From: Alessandro Beccaluva <[REDACTED]@AKT-UK.COM>
Sent: 07 January 2019 09:33
To: Ione Varela; Anderson Scott
Cc: Maguire Susanne; Nicholas Mitchell; Lucie Olivier; 3841 - South Kensington Station; Easton Fraser; Phiniefs Christopher; Enson Tu; [REDACTED]@native-land.com; Geary Rick; David Easton; Speer Michael; Gray Kate; Narita Anda
Subject: RE: 3841 - South Kensington station - Record information and design items

From: Ione Varela
Sent: 13 December 2018 18:32
To: Anderson Scott
Cc: Maguire Susanne; Nicholas Mitchell; Lucie Olivier; 3841 - South Kensington Station; [REDACTED]@tfl.gov.uk; [REDACTED]@tube.tfl.gov.uk; Enson Tu; [REDACTED]@native-land.com; [REDACTED]@tfl.gov.uk; David Easton; [REDACTED]@tfl.gov.uk; [REDACTED]@tfl.gov.uk; [REDACTED]@tfl.gov.uk
Subject: 3841 - South Kensington station - Record information and design items

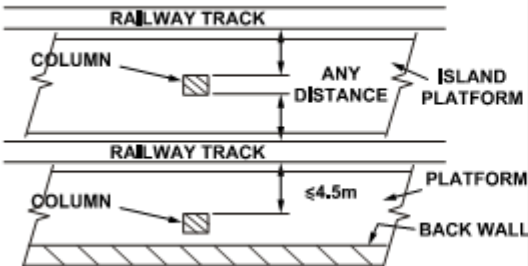
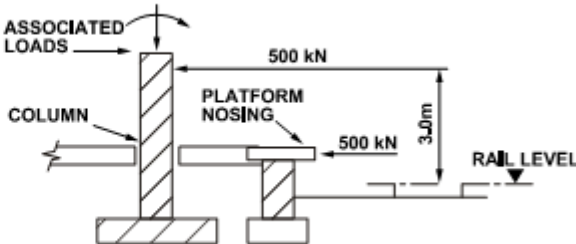
1. Accidental impact loads on all columns within the derailment zone on platforms are as stated in Figure 1 in TFL document S1053 (see extract below).

This is namely that the platform itself is designed by TFL to withstand a 500kN impact and provided the proposed building columns are suitably isolated as they thread through the platform they only need to withstand a design accidental load of 500kN at 3.0m above rail level in any direction non-concurrently. Please confirm that this understanding is correct.
